**Re: Request for Modification of State Water Resources Control Board Target
Elevation for Pinecrest Lake by Labor Day; Spring Gap-Stanislaus Hydroelectric
Project, FERC Project No. 2130**

PINECREST LAKE LEVEL STUDY MITIGATION PROPOSAL

**Spring Gap-Stanislaus Project
(FERC Project No. 2130)**

Figure 3-2. Typical Mud Flat.

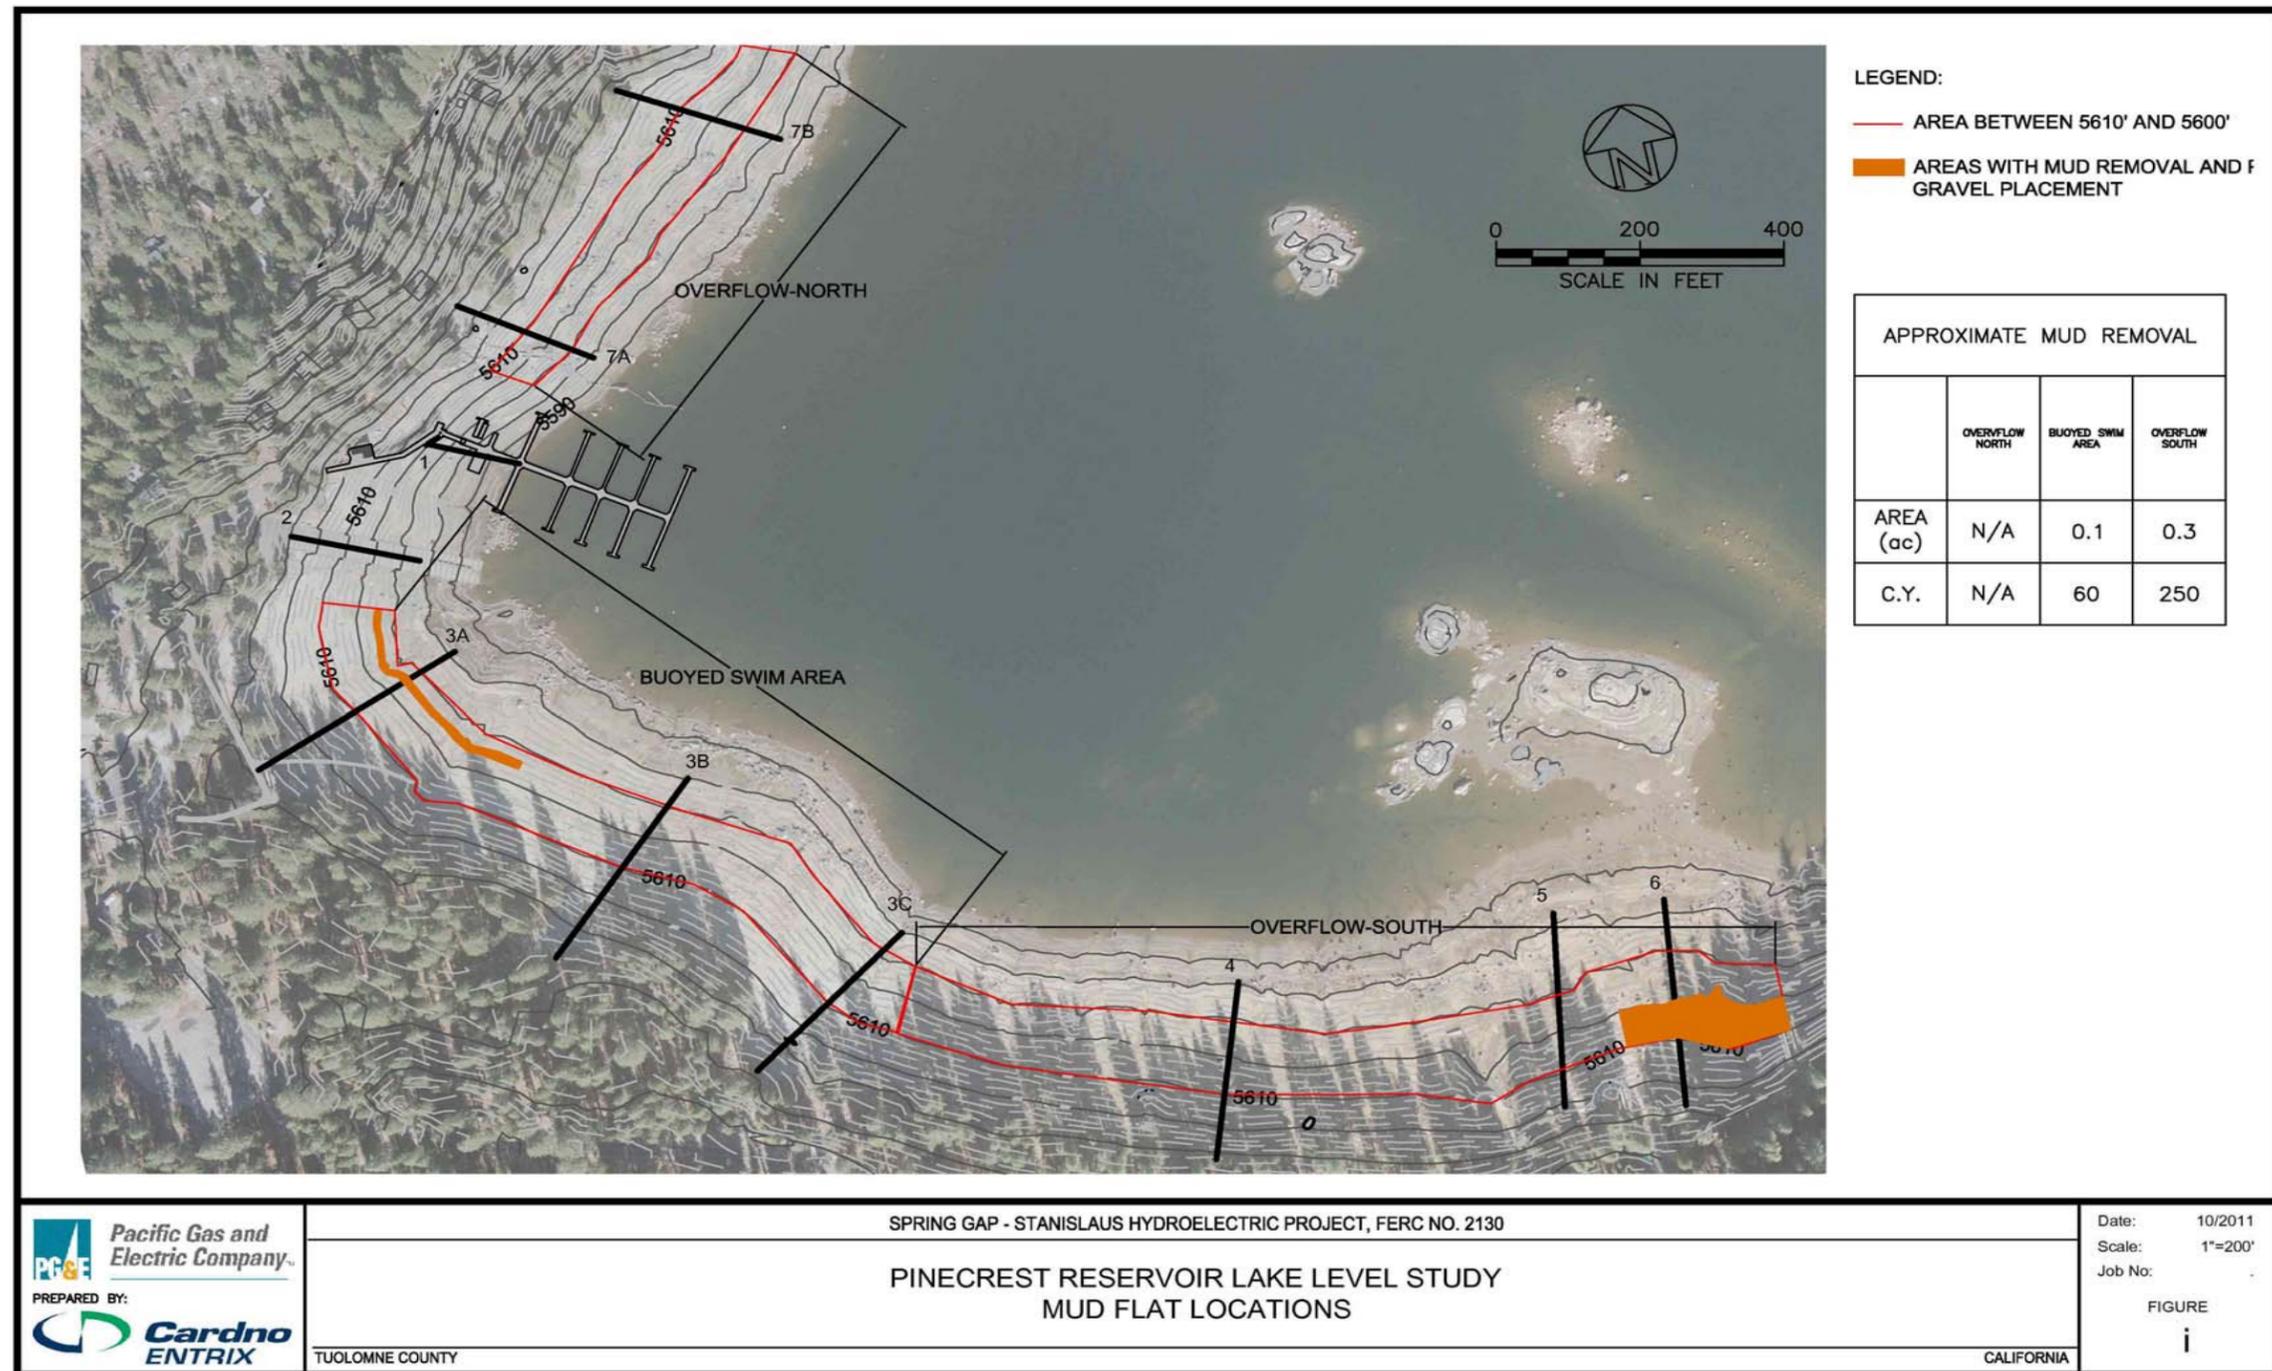
1. Transect 3A: Elevation 5,602 (Figure 3-2)
2. Transect 3B: None
3. Transect 3C: None
4. Transect 4:None
5. Transect 6:Elevations 5,610, 5,608, 5,607, 5,606, 5,605
6. Transect 7A: None
7. Transect 7B None

Figure 3-3. Approximate Locations of Mud Removal.

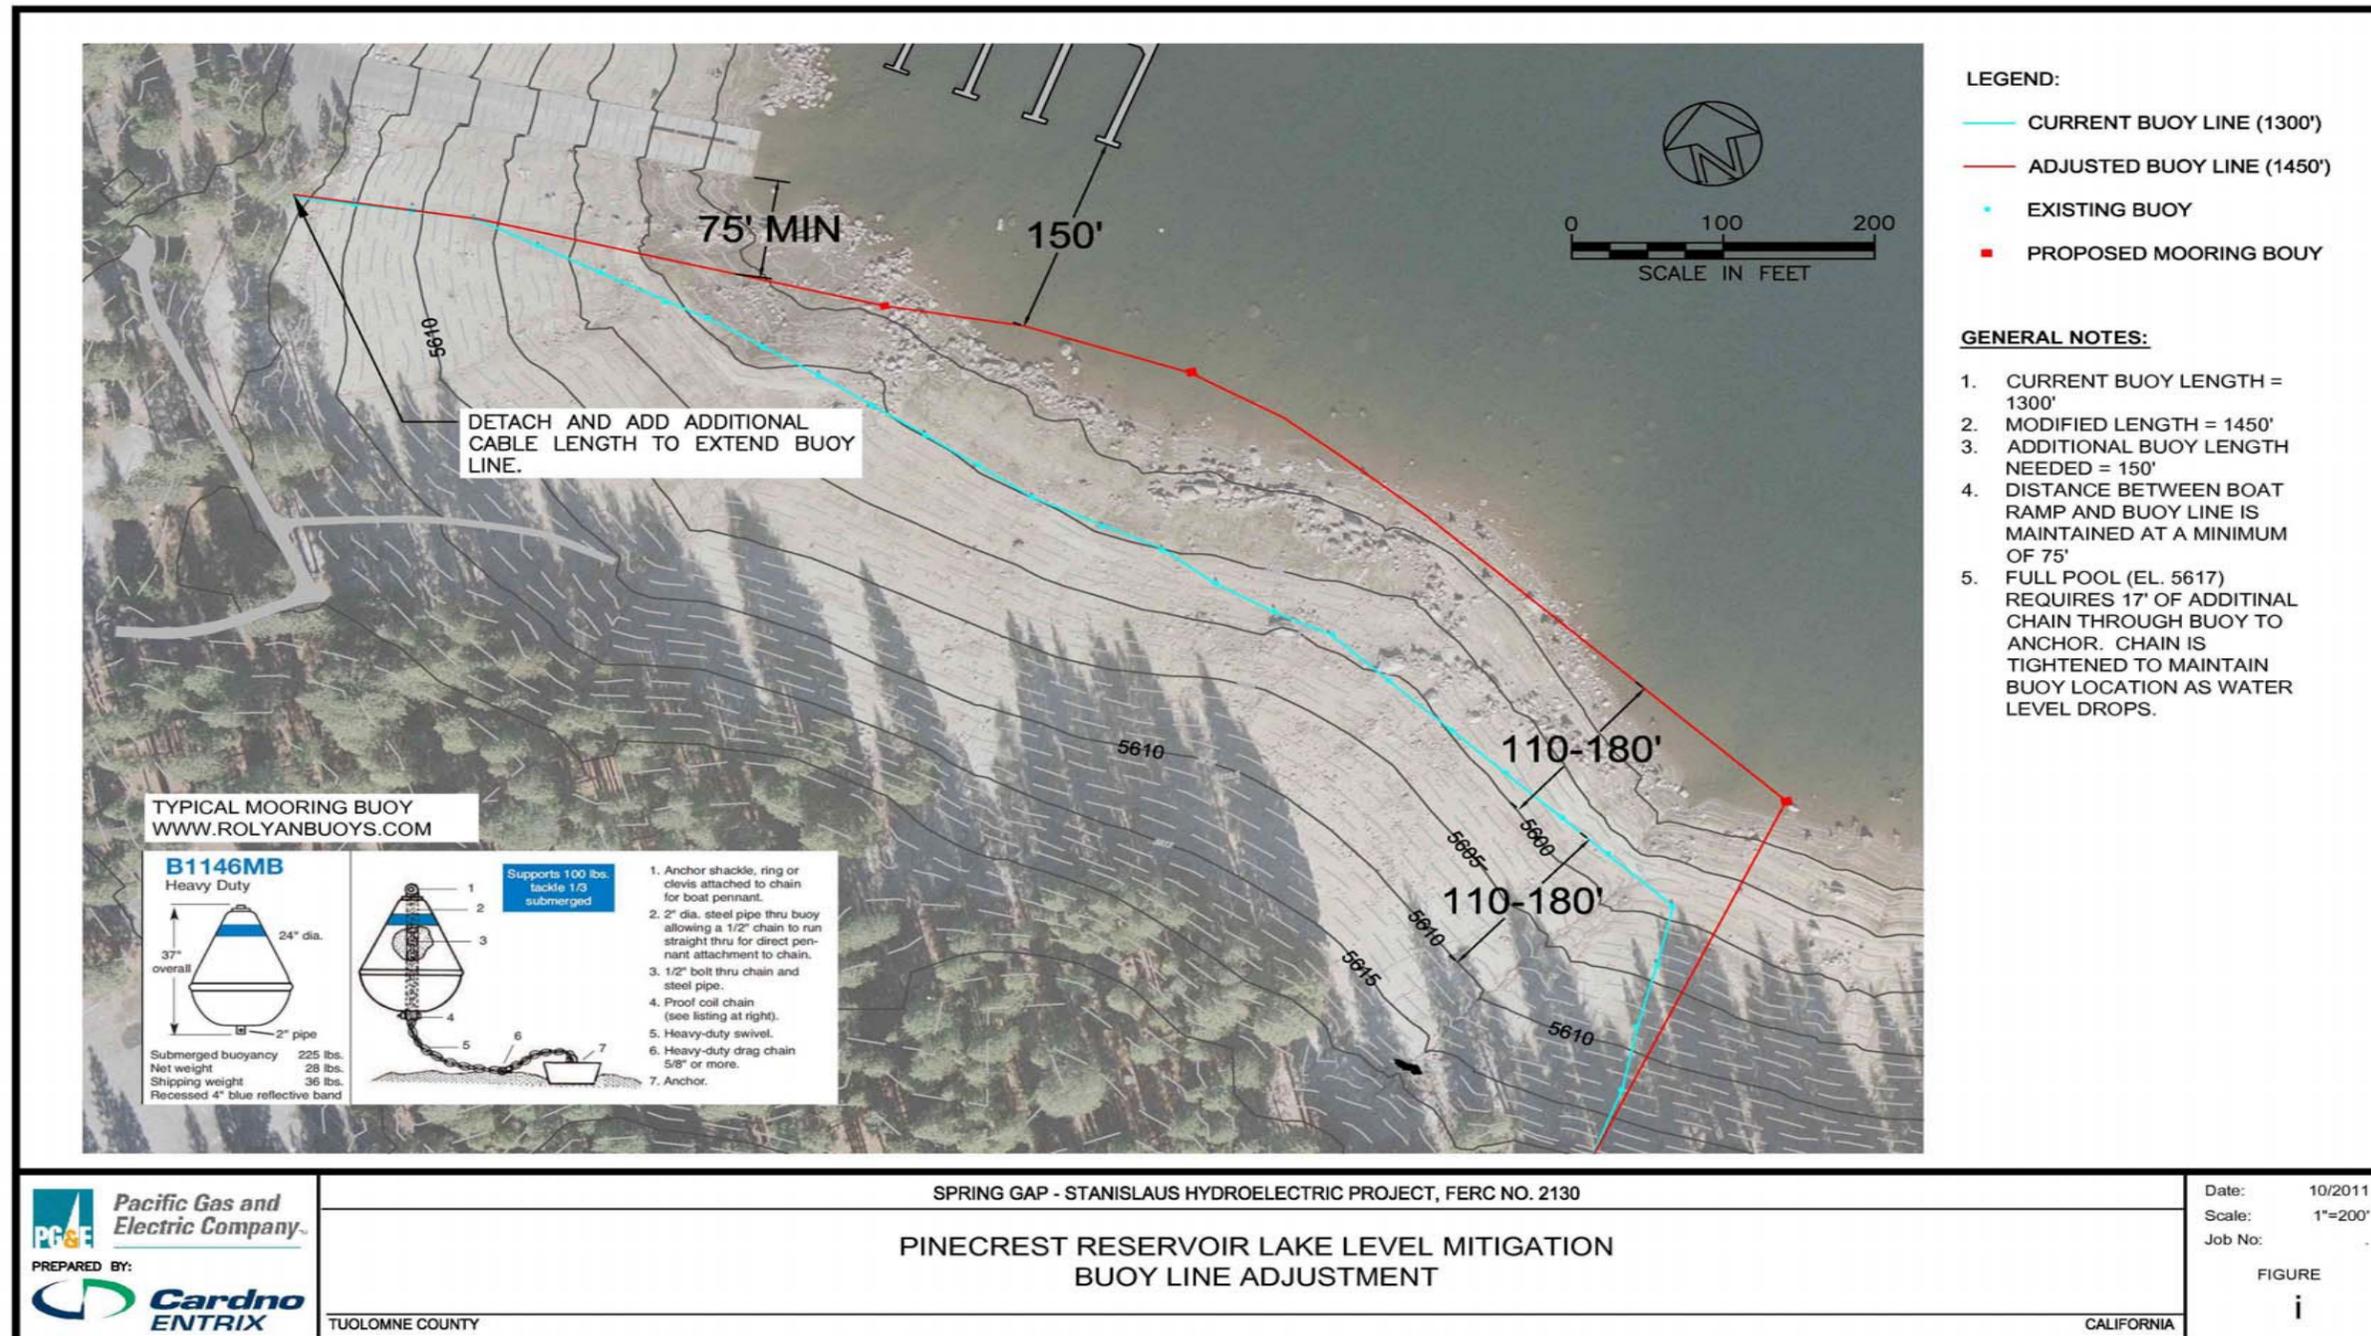
As mitigation, areas with excessive mud, approximate locations shown in Figure 3-3, will be excavated to a depth of 0.5 ft and back filled with rounded gravel (not crushed), as directed by the Forest Service.
